Monterey Bay Sanctuary Scenic Trail Network Master Plan

Addendum #3 to the Environmental Impact Report Segment 18 SCH#2012082075

April 2020

Figure 3 Modified Segment 18 Project Revised Walker Street Railroad Crossing

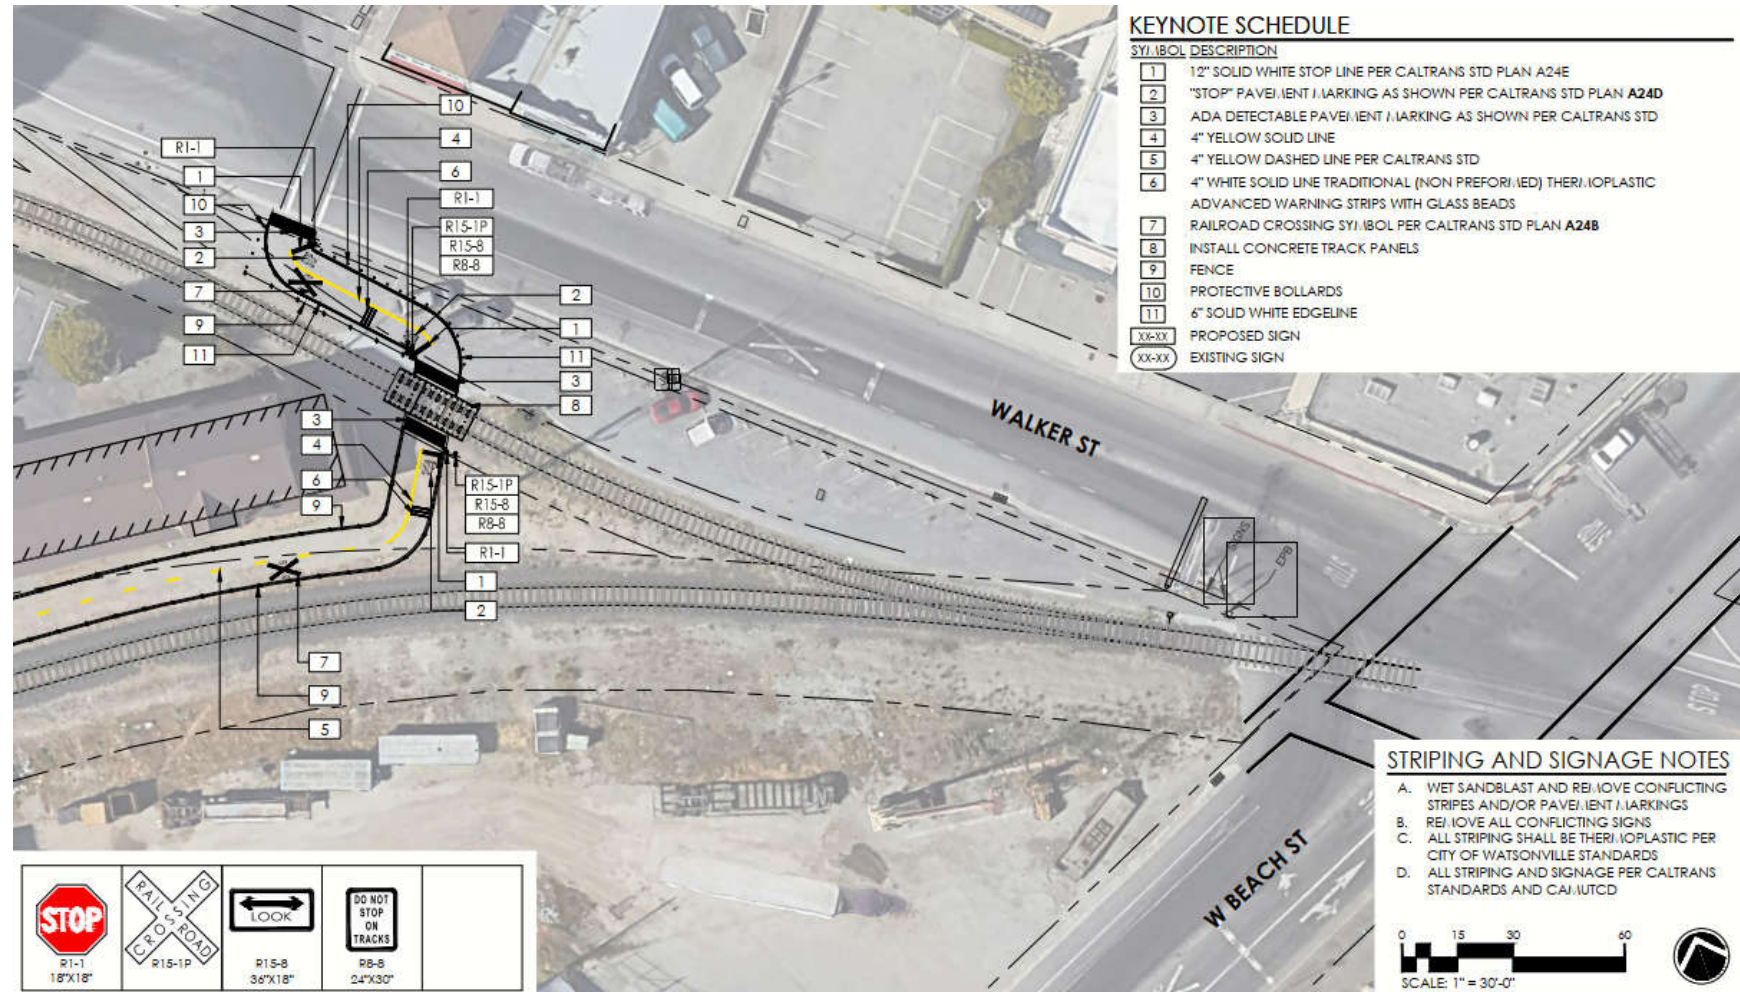
Both crossings would include safety features for crossing, as shown in Figure 3 and Figure 4. The trail would include a railroad crossing symbol as trail users approach the crossings, “Stop” pavement markings, ADA detectable pavement markings, concrete track panels, protective bollards, signage, and fencing.

The Modified Segment 18 Project would be located in the same area as the Original Project but would realign the trail at two railroad track crossing locations. The first crossing would be 80 feet northeast of the crossing proposed as part of the Original Project near Walker Street and the second crossing would shift the crossing proposed at the “Couch Spur” in the Original Project to cross the main railroad line in the same area. The visual character of Segment 18 through Watsonville ranges from urban and industrial to rural agricultural. The revised crossings would be within the corridor analyzed in the Original Project and would not include any features that would obstruct views or

Figure 4 Modified Segment 18 Project Revised Lee Road Railroad Crossing

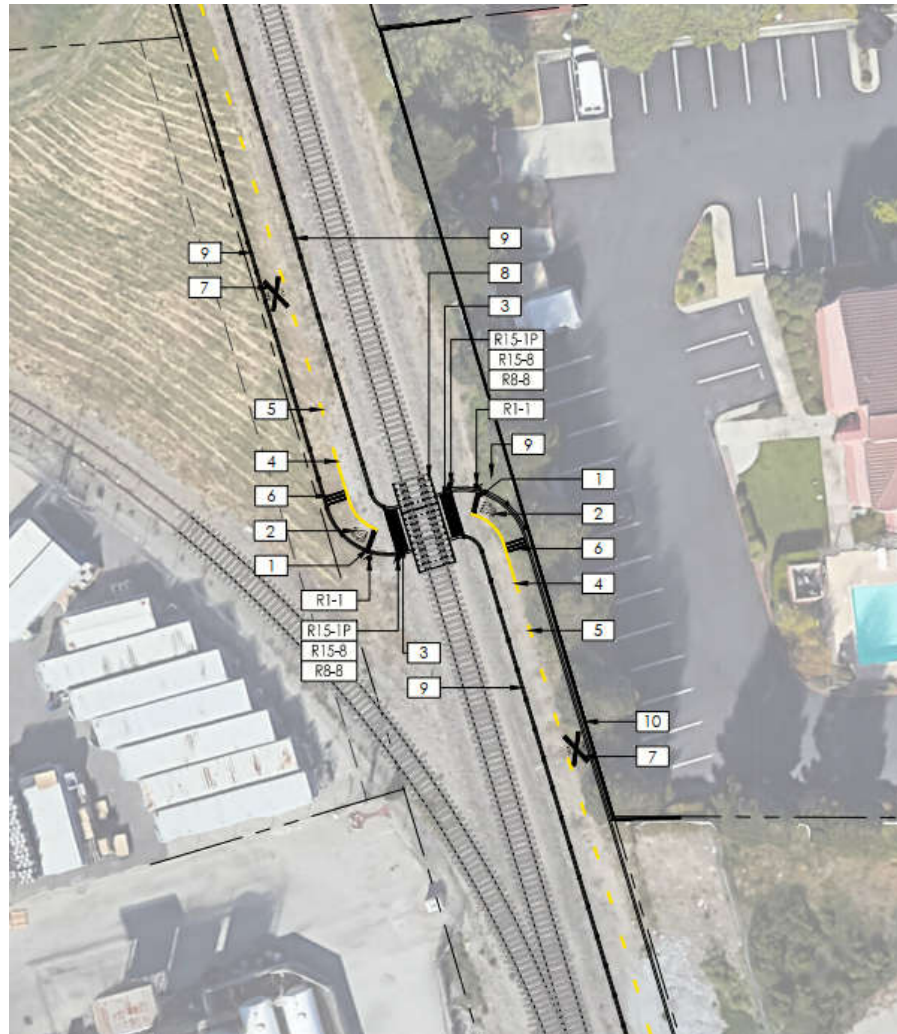
The proposed railroad track crossing near Lee Road and Couch Spur is within 100-year flood hazard area (Federal Emergency Management Agency 2012a). The proposed railroad track crossing near the old train depot building at Walker Street is within 500-year flood hazard area (Federal Emergency Management Agency 2012b). However, the location of the spur crossings evaluated in the certified Final EIR for the Original Project were also in 100- and 500-year flood hazard areas. Therefore, the Modified Segment 18 project would result in no additional railroad track crossings within flood hazard areas. Additionally, the proposed railroad crossings would be at grade with the existing railroad tracks and would not result in additional impediment or redirection of flood flows.
